SUBJECT: Change Order #5 to CC-2098-07/DRR - Yankee Lake WRF PH I Improvements and Greenwood Lakes WWTF Biosolids Dewatering Improvements

SEMINOLE COUNTY, FLORIDA
CHANGE ORDER FOR CONSTRUCTION PROJECTS

Contract Title:
Yankee Lake and Greenwood Lakes Re-Rate Project

YANKEE LAKE – GREENWOOD LAKES RE-RATE**CC-2098-07/DRR****CIP #195201****WBS #10303004****Change Order #005 Summary:**

RFI Number	119
Project Name	Yankee Lake / Greenwood Lakes Re-Rate
Contractor	Florida Design Contractors
CIP Number	195201
WBS Number	10303004
Date Submitted	05/01/08
Prepared By	Jeffrey Holst
Sheet Number	D-101, D-301
Specification

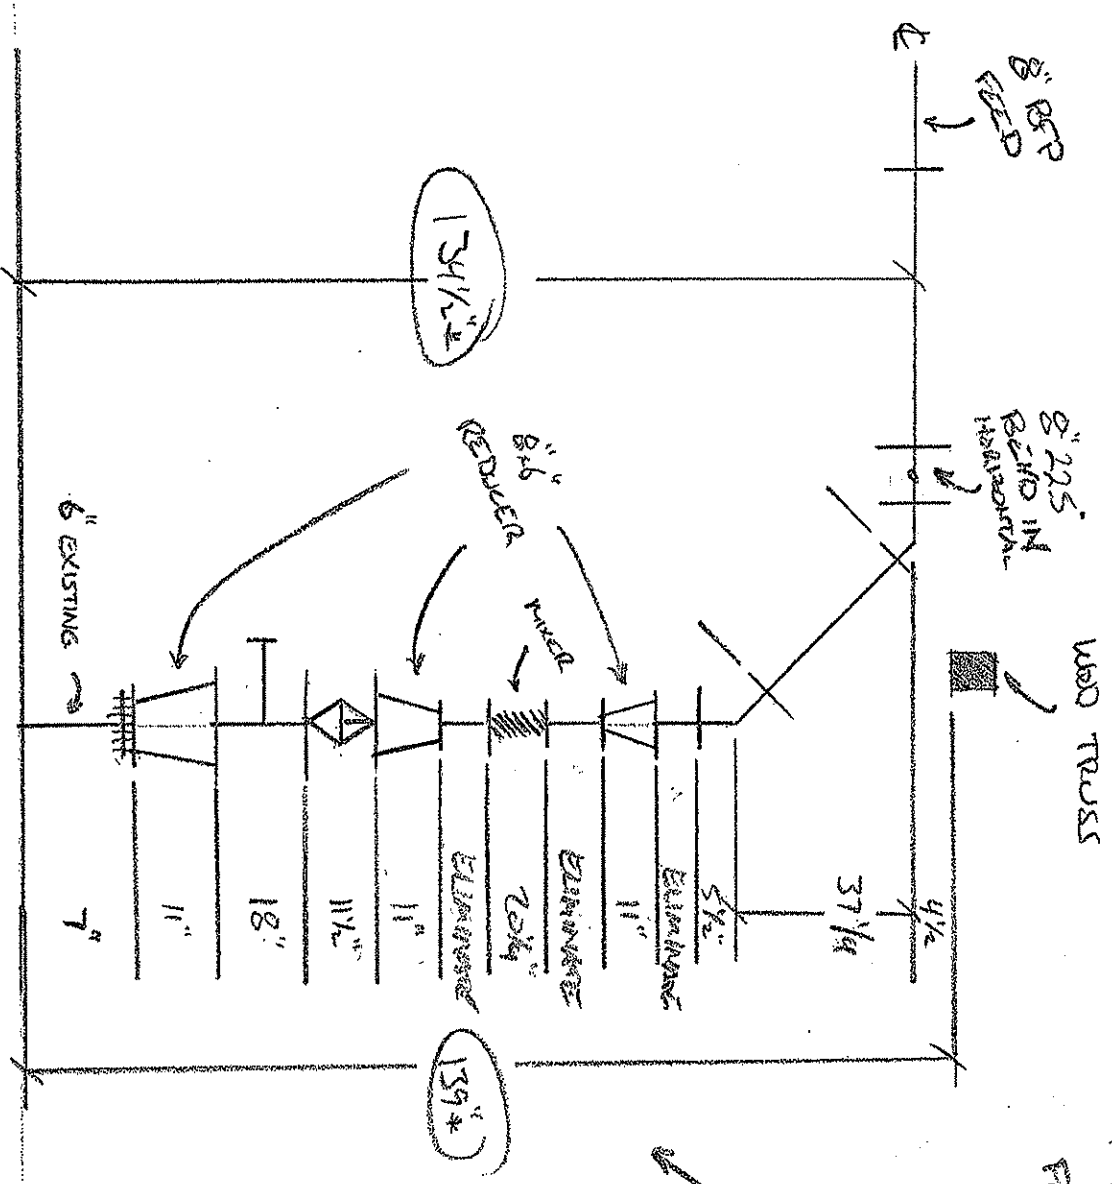
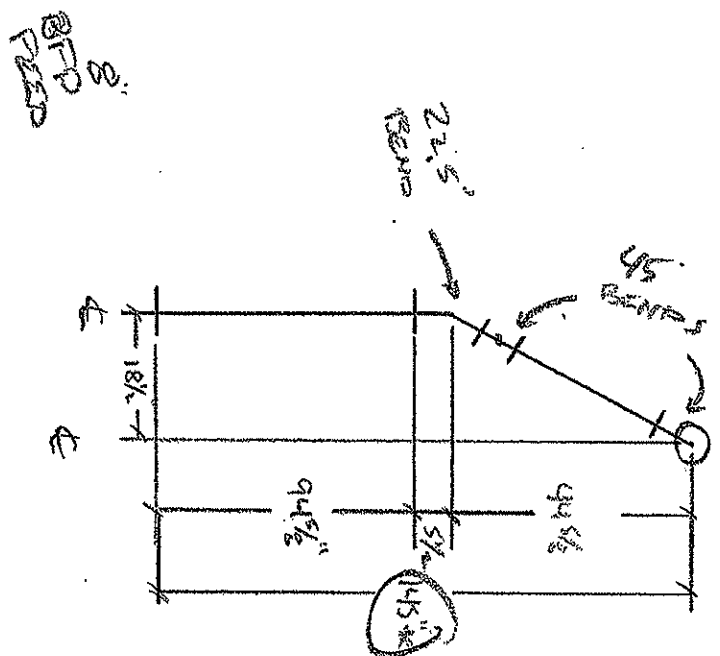
DESCRIPTION: Provide material and labor to implement necessary changes to BFP feed piping design due to offset between the press and the existing feed pipe stub up shown on the attached, accepted layout sketch per the response to RFI #119. Sales tax of 6% shown on this form.

We have no objections to the proposed modifications.

FIELD ORDER #27
YAWKEE LAKE D-504(56)

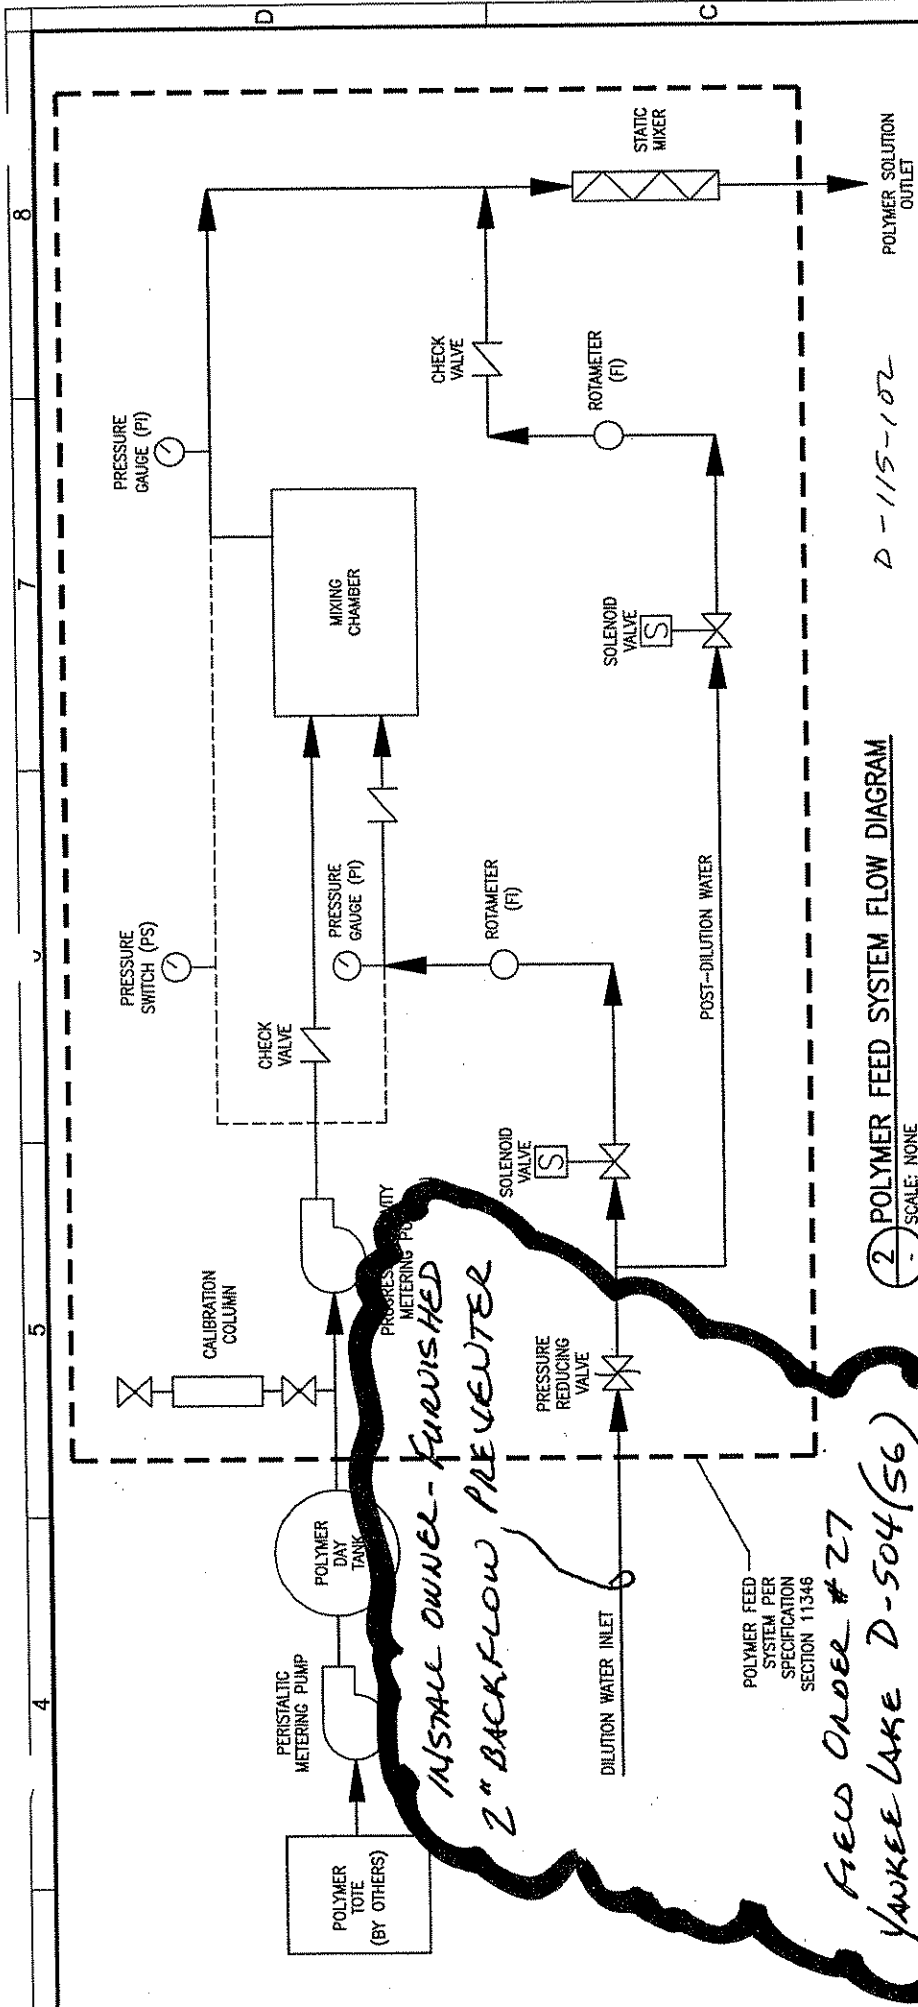
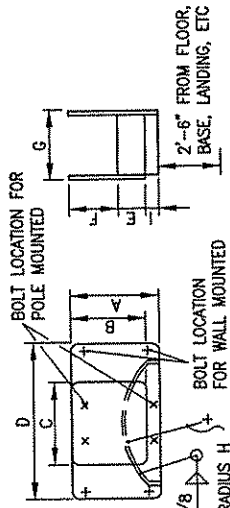
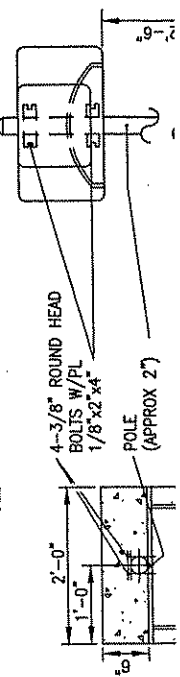
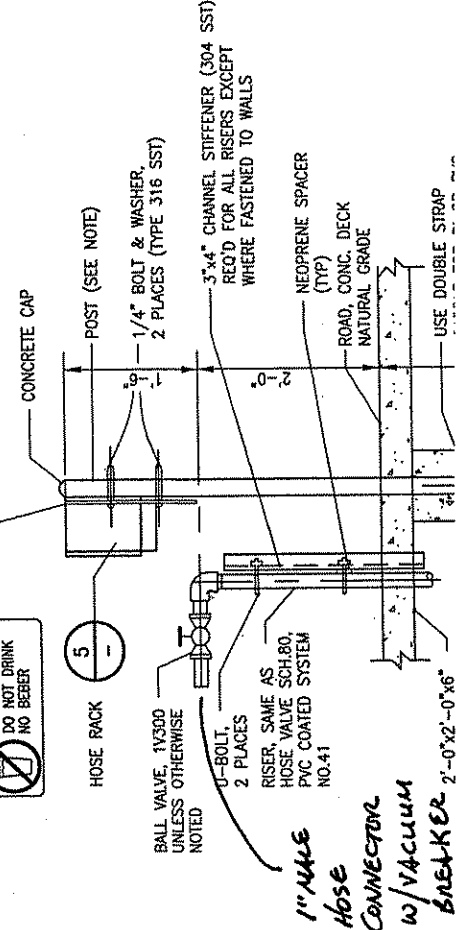
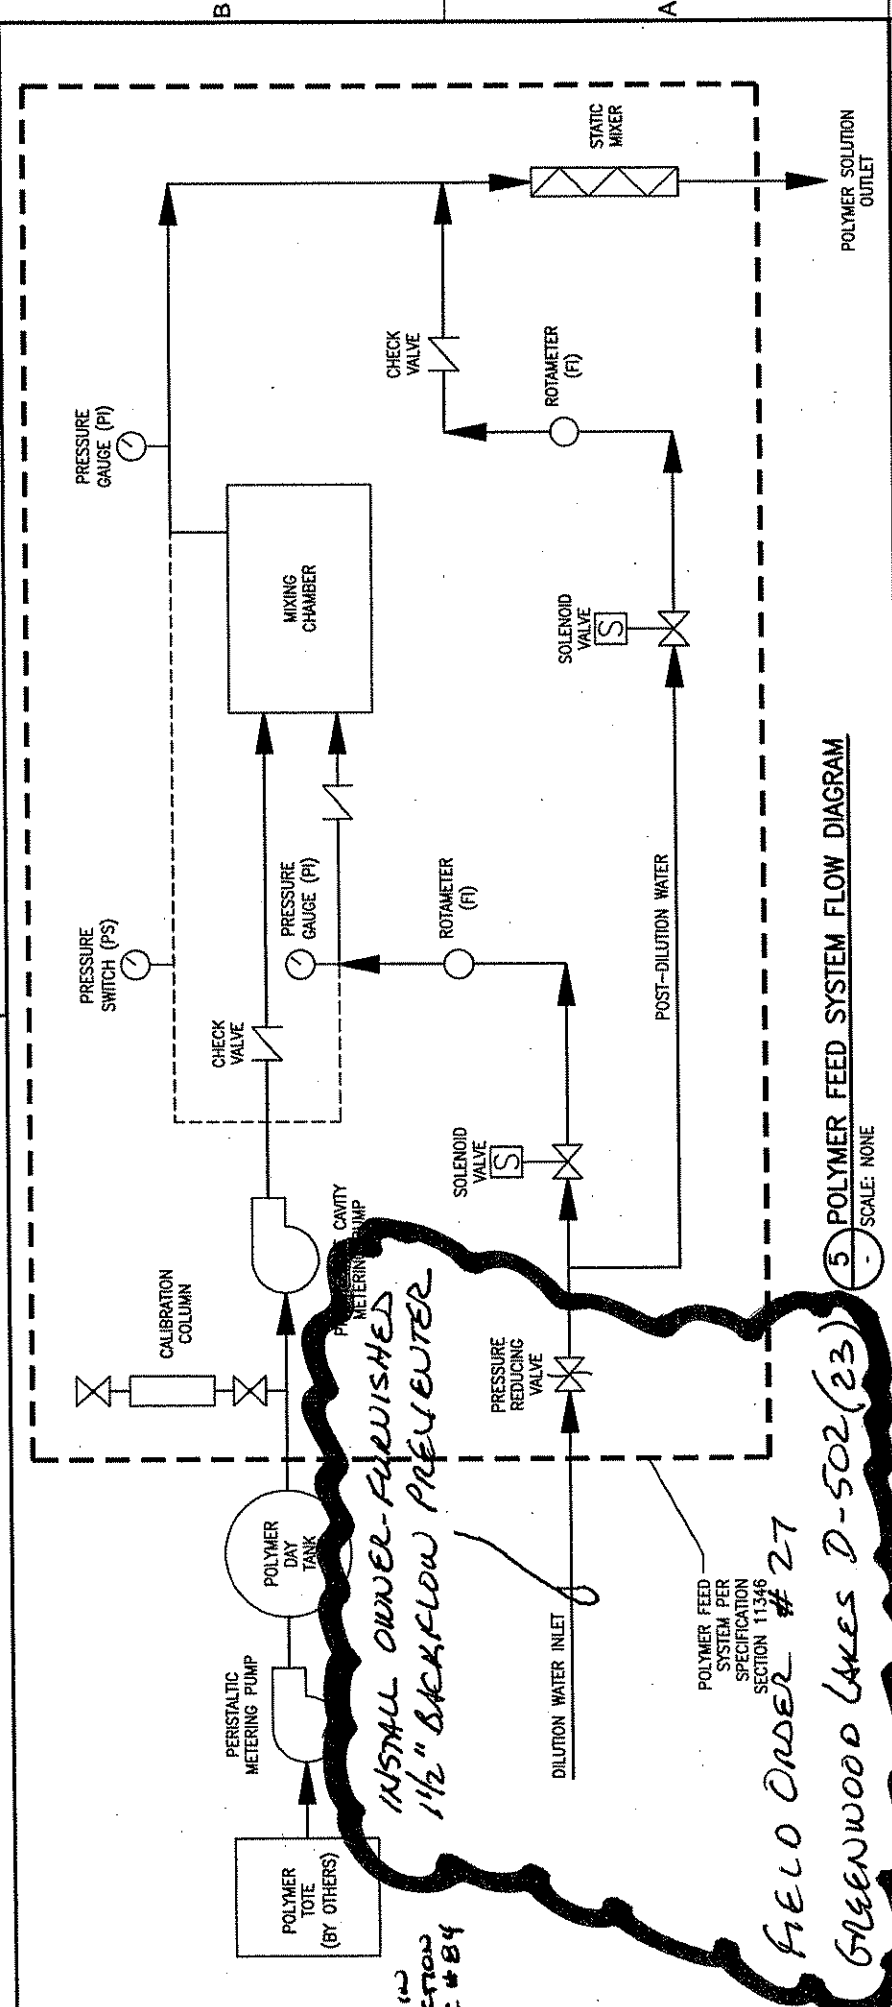
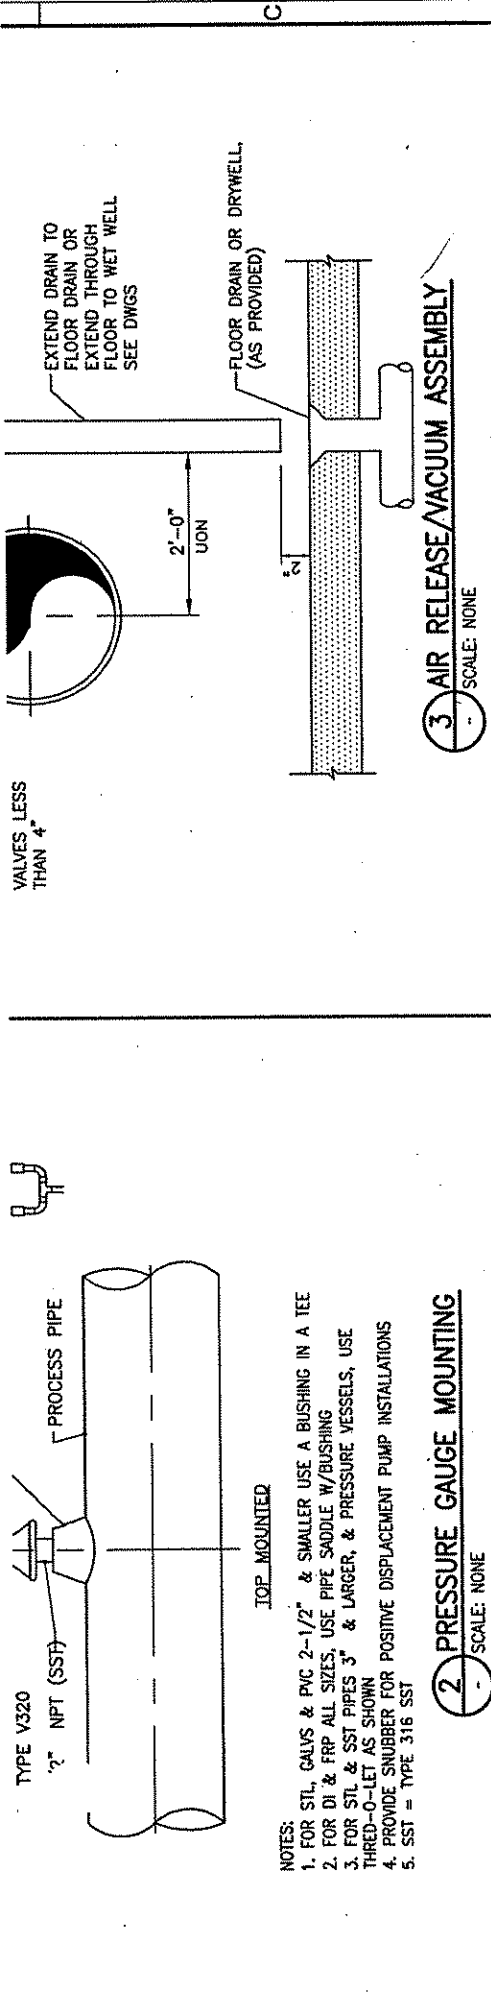
1. Install Owner-Furnished backflow preventer on the potable water line to the Polymer system at both sites. Refer to the attached marked up detail 2 on D-504 (56) and detail 5 on D-502 (23).

INSTALL OWNER-FURNISHED
2" BACKFLOW PREVENTER

RFI Number	127 (revised response)
Project Name	Yankee Lake / Greenwood Lakes Re-Rate
Contractor	Florida Design Contractors
CIP Number	195201
WBS Number	10303004
Date Submitted	05/21/08
Prepared By	Allen Bigelow
Sheet Number	GWLD-101
Specification	05520

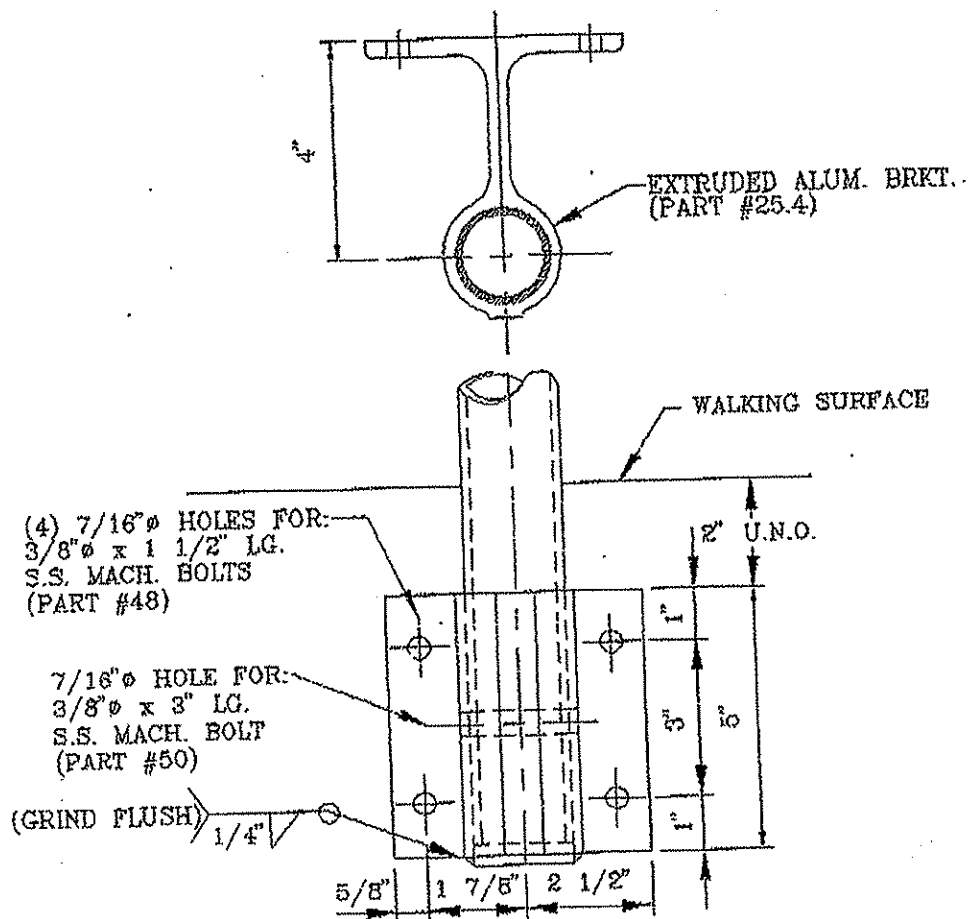
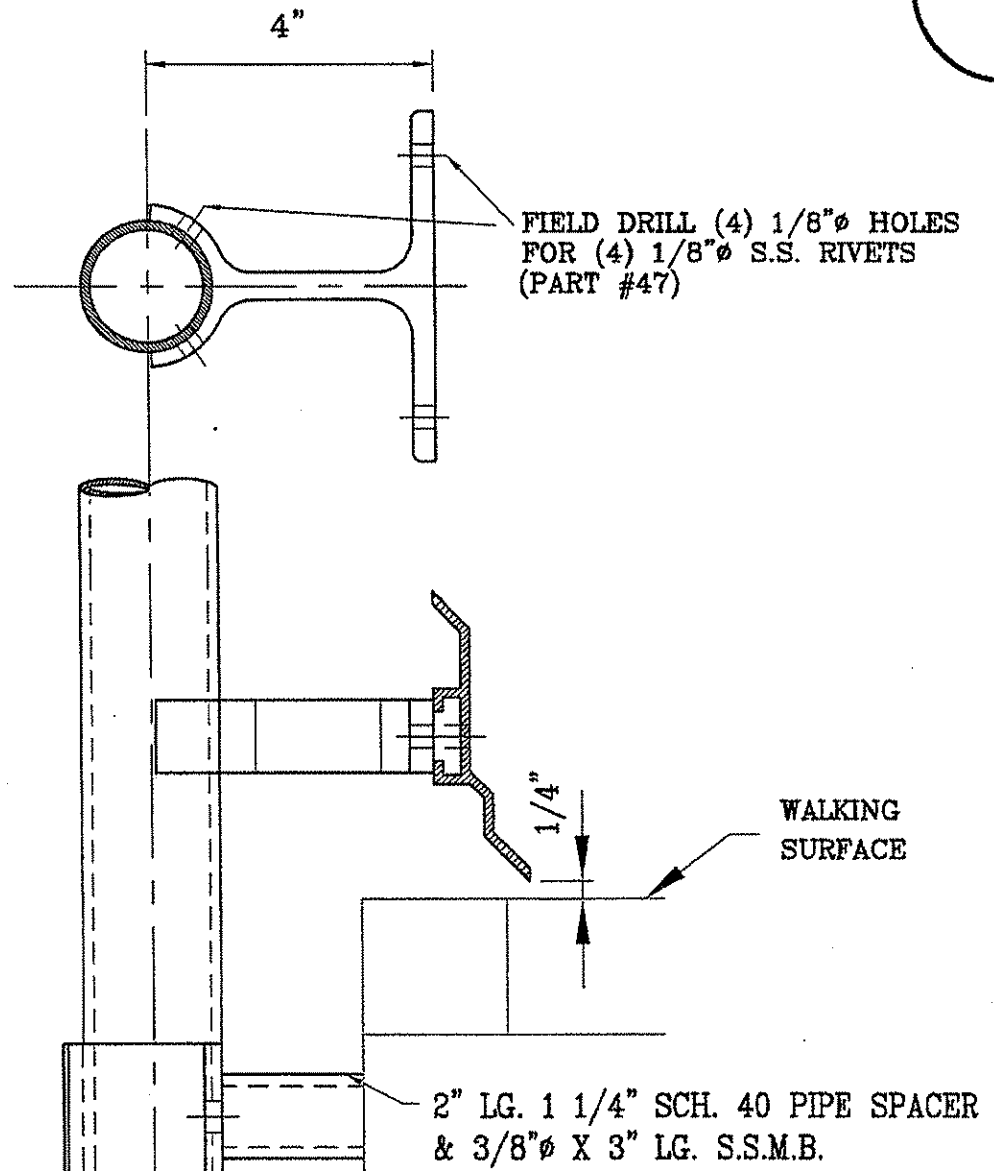
1. In RFI #95, it was requested that the handrail at Greenwood Lakes be modified so that it stopped 2 feet short of the west side of the Andritz Control Panel and to install safety chain from that point to a post at the NW corner. The Owner would prefer not to have safety chain in this location. There are a couple of options. Please indicate which is preferred.

Attached, please see the details from GRI for offsetting the handrail and toe board on the affected side of the walkway only. Confirm distance offset provided will allow the door to clear before proceeding. Both parts called out in the attached drawings are available from GRI with no delay.
